No. EL/11.5.5/21 Dated: As signed

Modification sheet no. RDSO/2018/EL/MS/0475 (Rev.'1)

Modification in the existing CE resetting scheme to reset the control electronics (VCU) in Multiple Unit Locos.

- v. Modified scheme for resetting of Slave locomotive VCU from Master Loco is attached at Annexure-1 (Sheet No. 1-4).

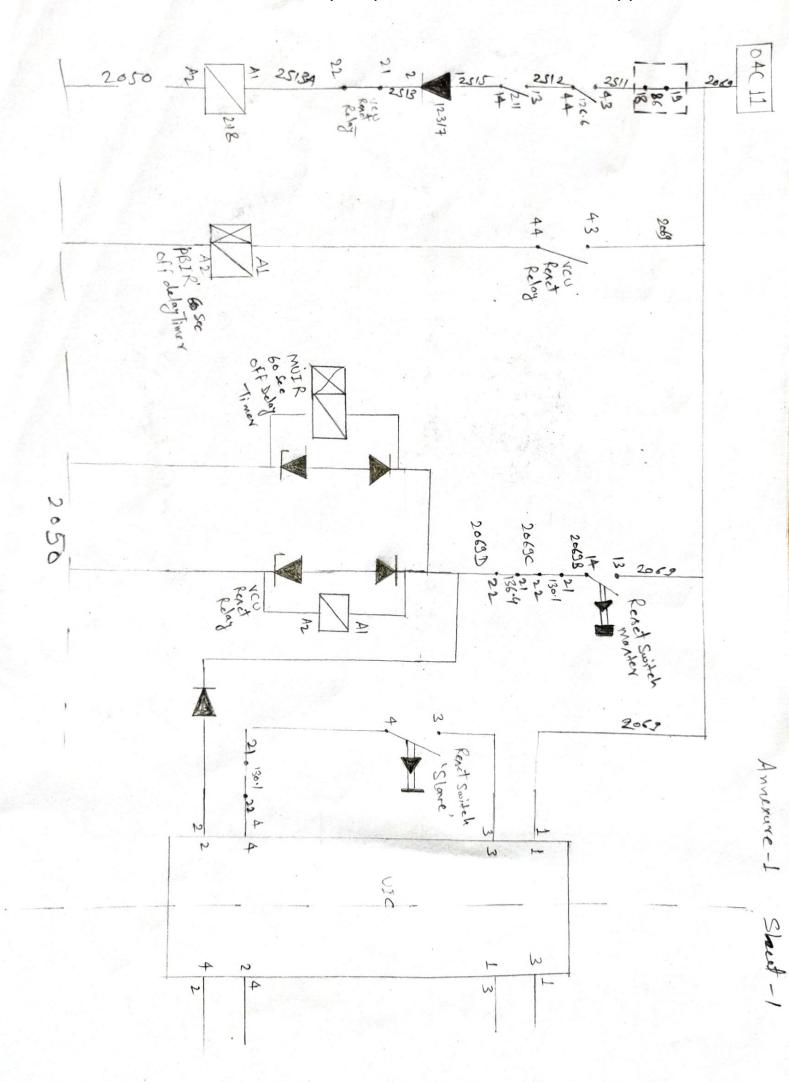
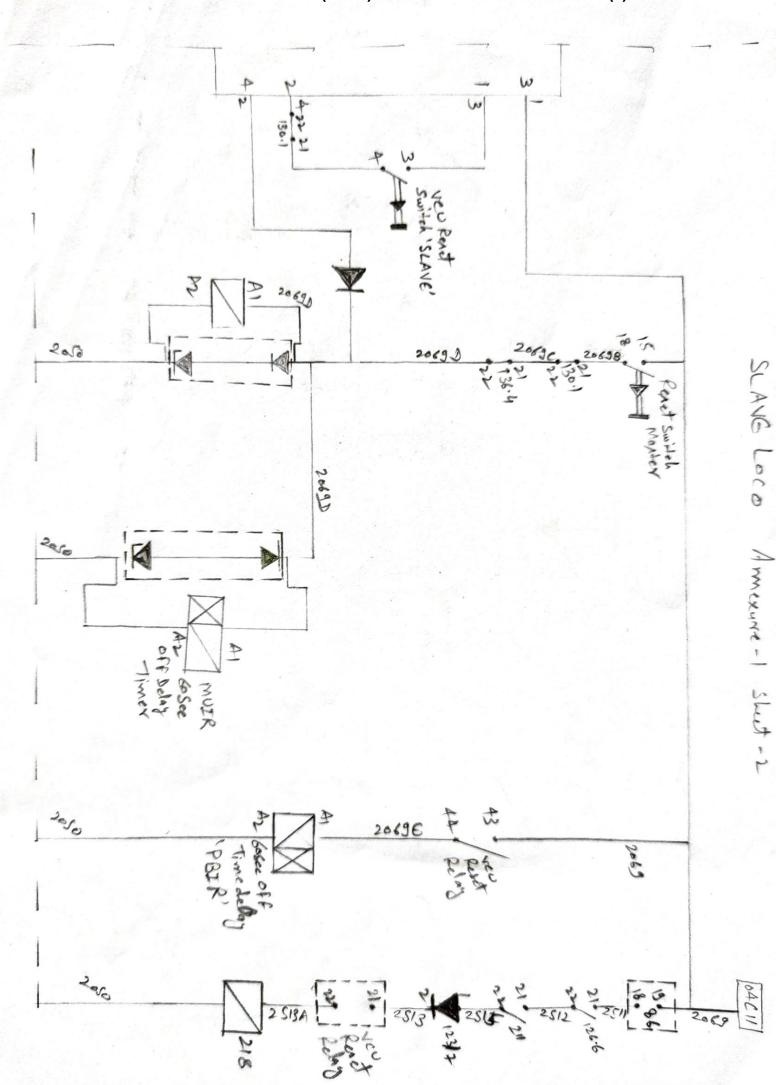
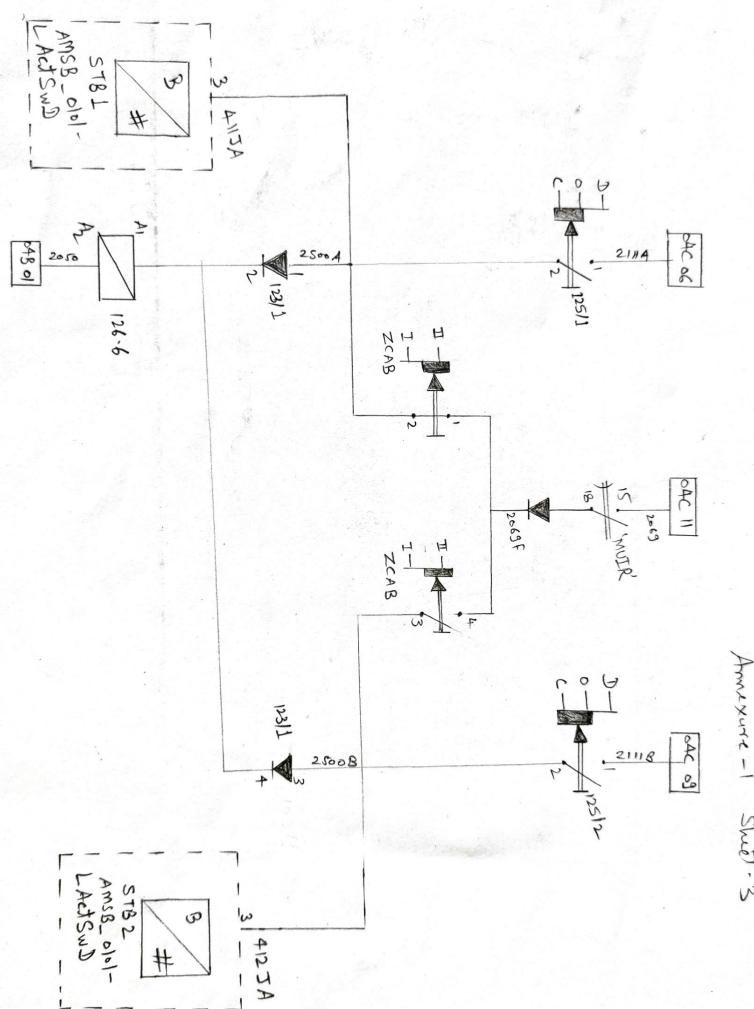
- i. 2 nos. reset push button switches to be provided in SB-1 panel and designated as 'Lead/Master' and 'Trail/Slave' VCU Reset Push Button. On pressing 'Lead/Master' switch, resetting of VCU of the leading/master locomotive will be done and in multiple unit on pressing 'Trail/Slave' switch, resetting of VCU of the trailing/slave loco will be done.

- ii. Two numbers OFF time delay (60") relay (MUIR & PBIR), Type- REI7RMMW used in WAG9 class of loco, to be provided in SB-1. 'MUIR' will keep the safety relay control electronics ON (126.6) in energized condition for 60 seconds and provides signal to VCU to bypass Self Hold mode whereas 'PBIR' provides cab activation signal to VCU and keeps the contactor control circuit ON (126) in energized condition for 60 seconds in BL 'OFF' position while 'Trail/Slave' reset push button switch is pressed for resetting of VCU of trailing/slave locomotive.

- iii. One no. rotary program switch (ZCAB) to be provided in SB-1 for selection of driving cab during formation of multiple unit i.e. if cab-1 is driving cab then ZCAB to be put on '1' and if cab-2 is driving cab then ZCAB to be put on '2'.

- iv. 4 Pins of UIC coupler to be used to transmit the signal from either locomotive. Wire of Pin no. 1 connected with wire of Pin no. 3 and wire no. 2 connected with wire of Pin no. 4 in the UIC mobile coupler.
